Department of Energy
Washington, D.C. 20545

Docket No. 50-537

RESPONSES TO REQUEST FOR ADDITIONAL INFORMATION

Reference: Letter, P. S. Check to J. R. Longenecker, "CRBRP Request for Additional Information," dated February 19 and 26; March 11, 15, 23, and 25; and April 9, 1982

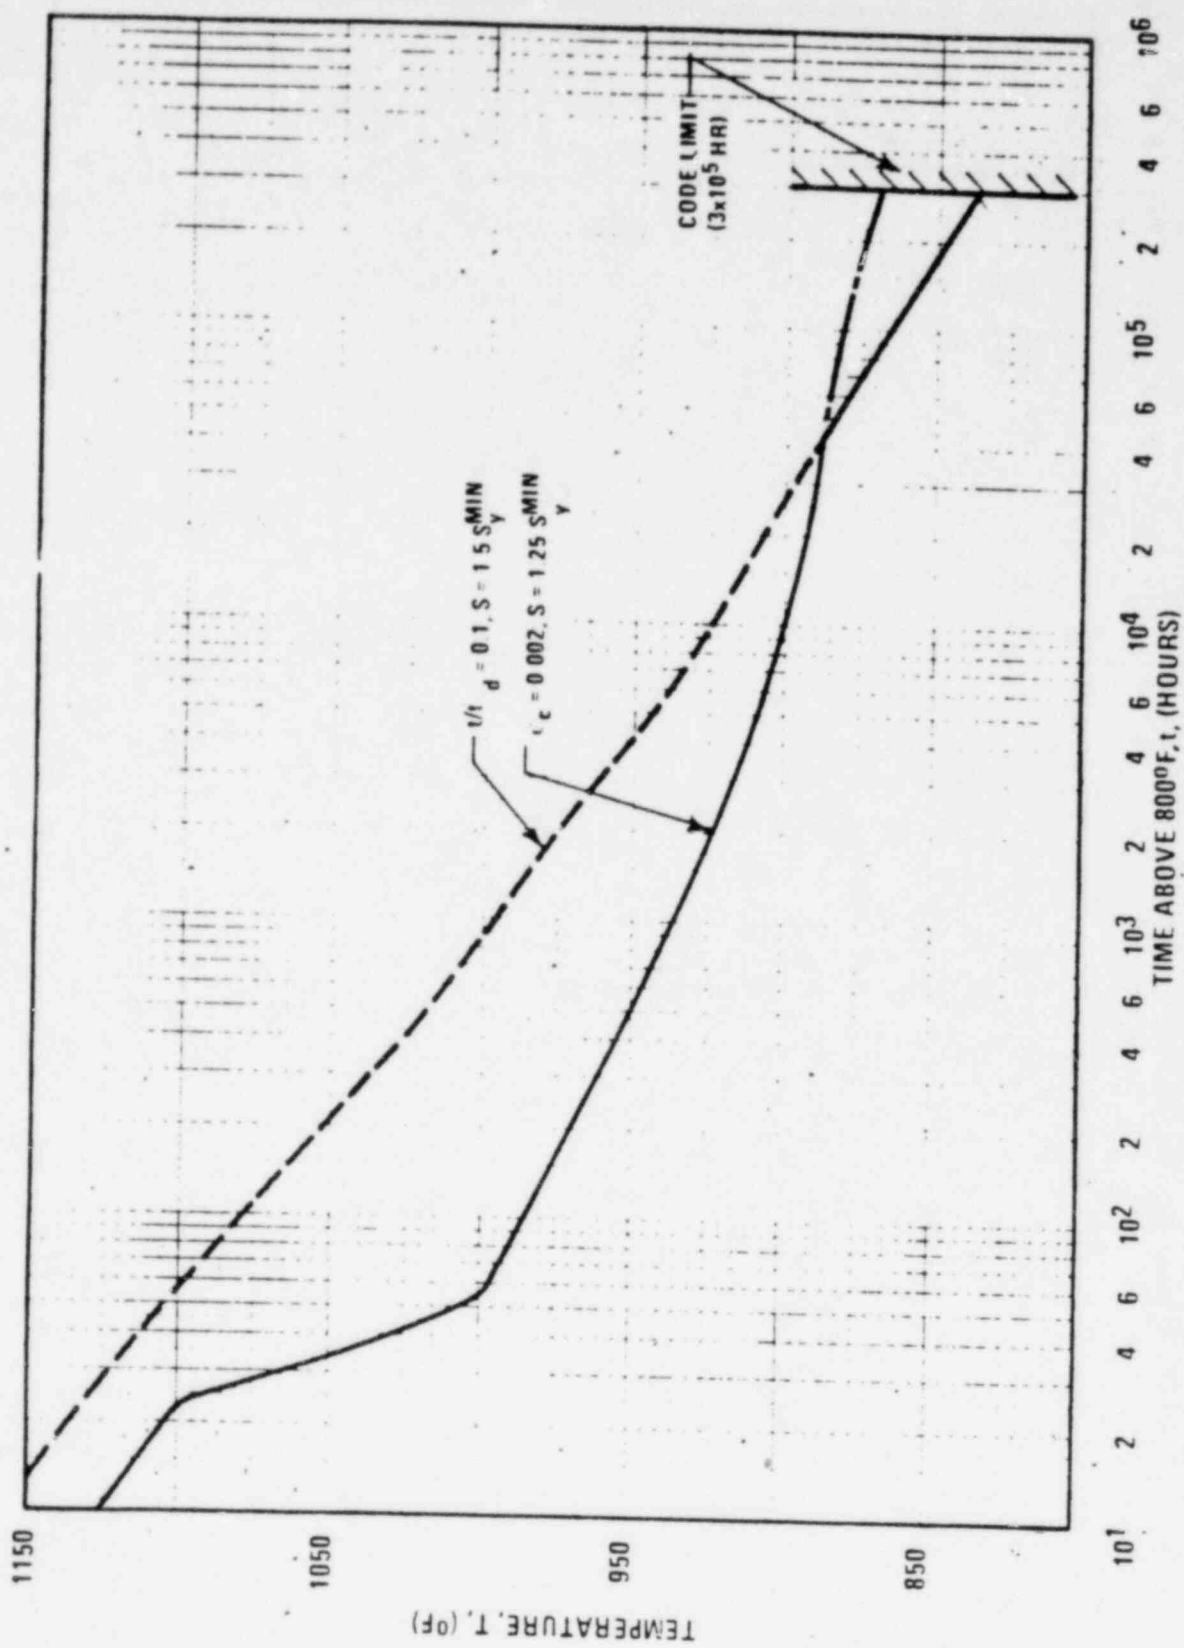
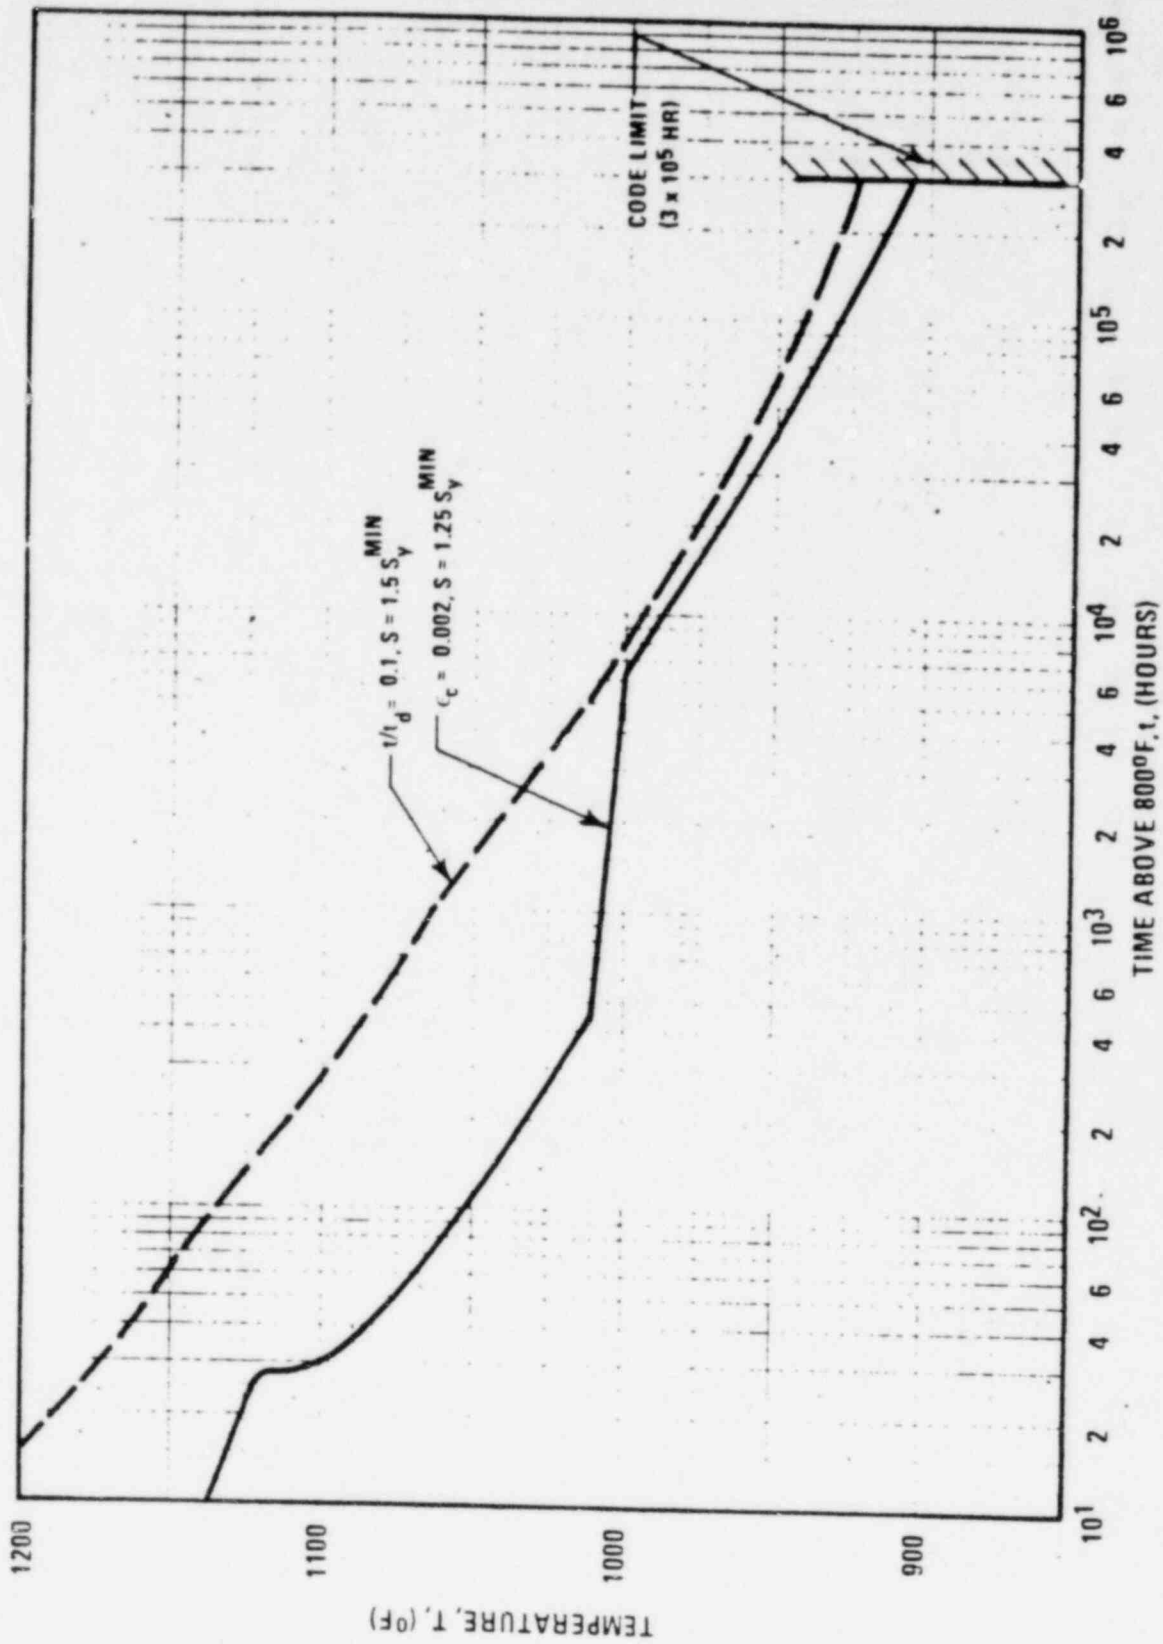
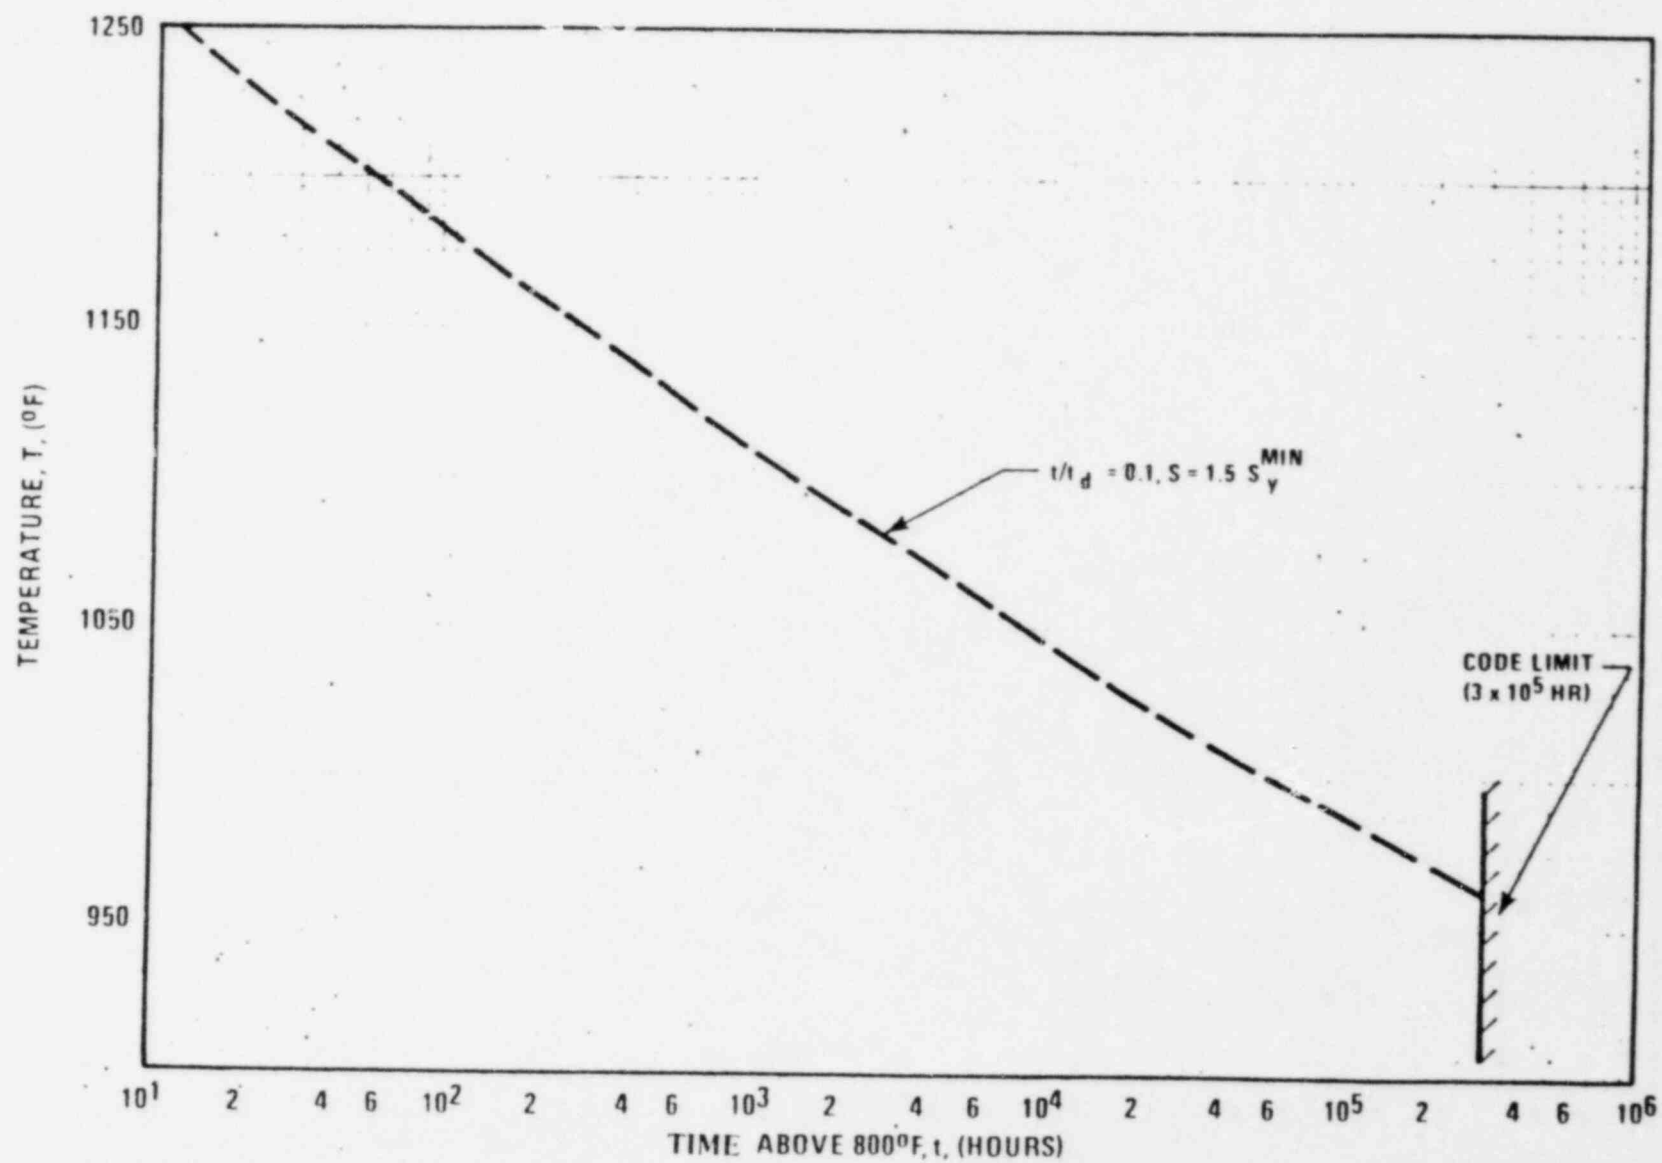
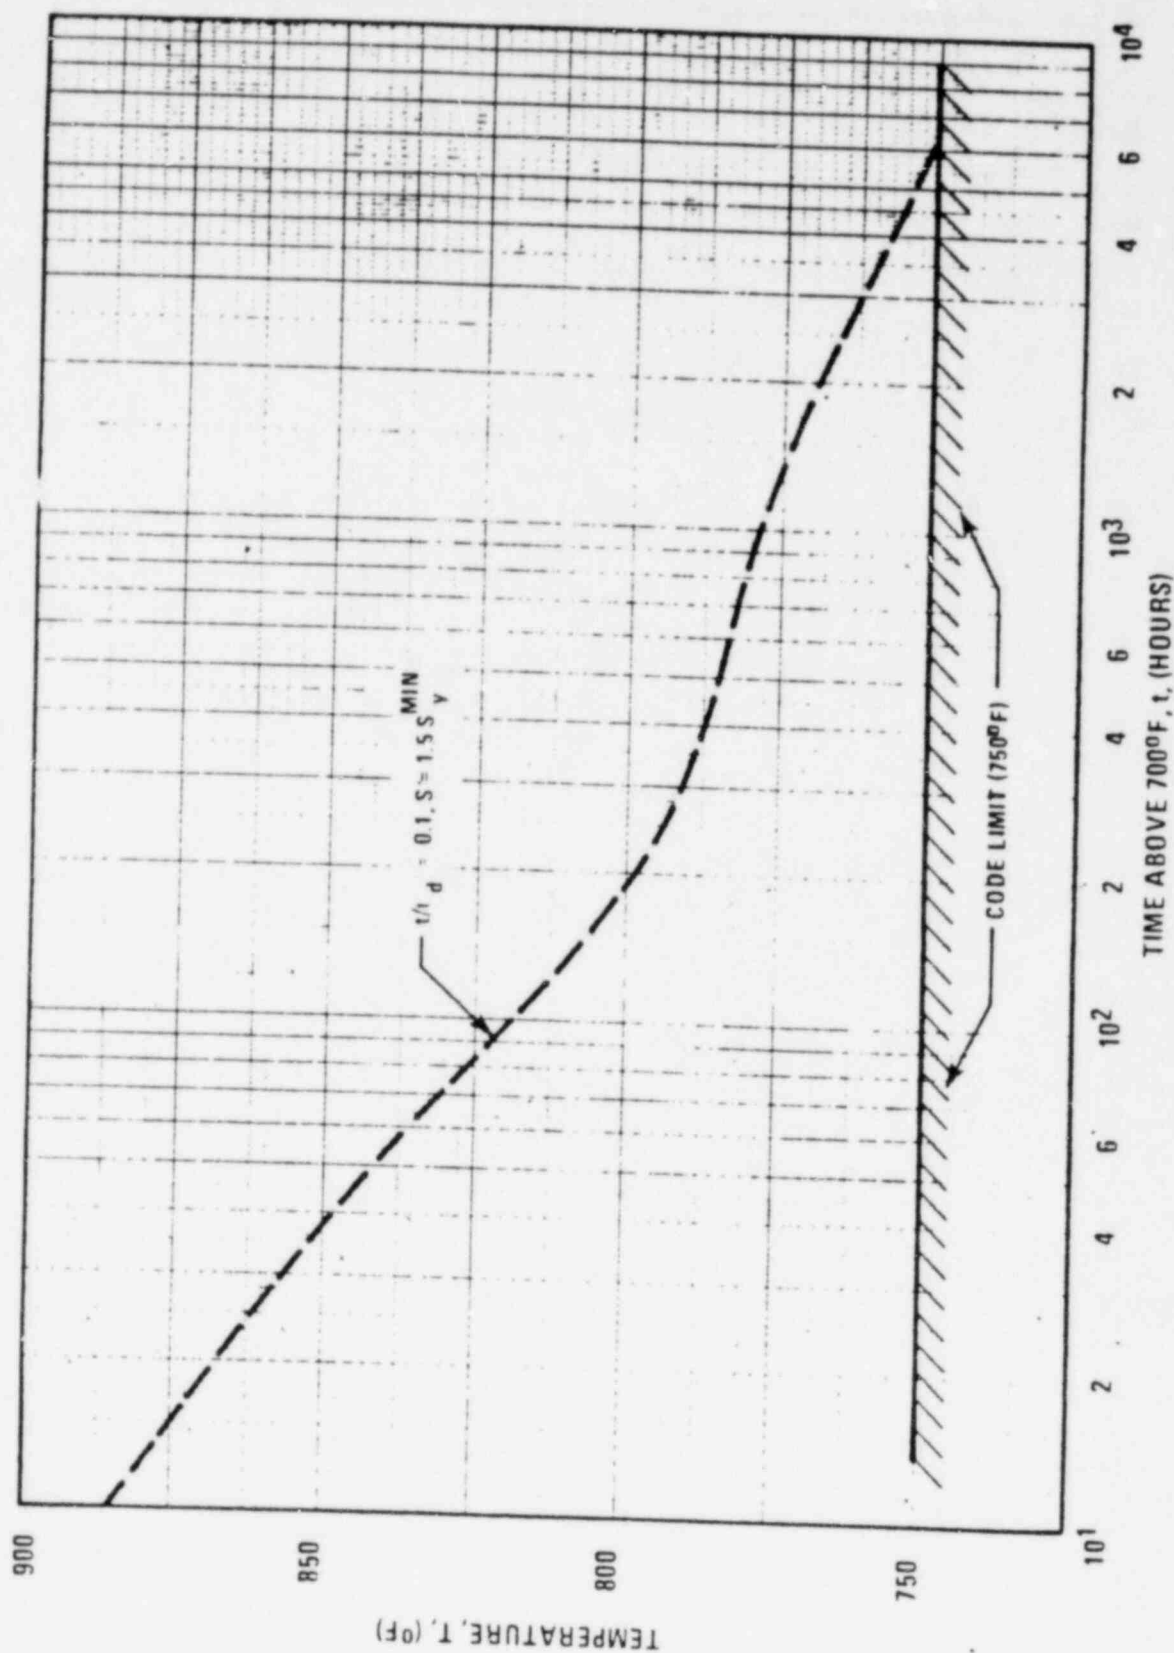
The ASME Section III Code does not require a fatigue evaluation for Class 2/3 piping design. However, for operating at elevated temperature, creep fatigue effects may become severe in Class 2/3 piping. Describe the method used for creep fatigue evaluation for Class 2/3 piping, or justify why such consideration is not needed. Furthermore, verify whether rules in Code Case N-253 are met.

In Appendix E of the CRBRP Modification to RDT Standard F9-4 (for use with Class 2 and 3 equipment) a time-temperature threshold is provided. When the time-temperature combination is below this limit, it is judged that low temperature fatigue and ratcheting rules may be used. Among the criteria used to define this threshold is the locus of points at which the time duration divided by the "allowable time duration" at 1.5 times the minimum yield strength is equal to 0.1. The "allowable time duration" is defined as the minimum time to rupture. Code Case 1592 provides the minimum time to rupture vs. stress and temperature (S_R^{\min}) over a range of stress and temperature values. The yield strength varies relatively slowly with temperature while the minimum stress to rupture value is very temperature sensitive. Thus, at low temperatures ($\sim 800^\circ\text{F}$ austenitic steels, $\sim 700^\circ\text{F}$ low alloy steels) 1.5 times the minimum yield strength may be smaller than the minimum stress to cause rupture, even at 1.0×10^5 to 3×10^5 hours. Thus, extrapolation of the stress-rupture curves to time above 3×10^5 is necessary.
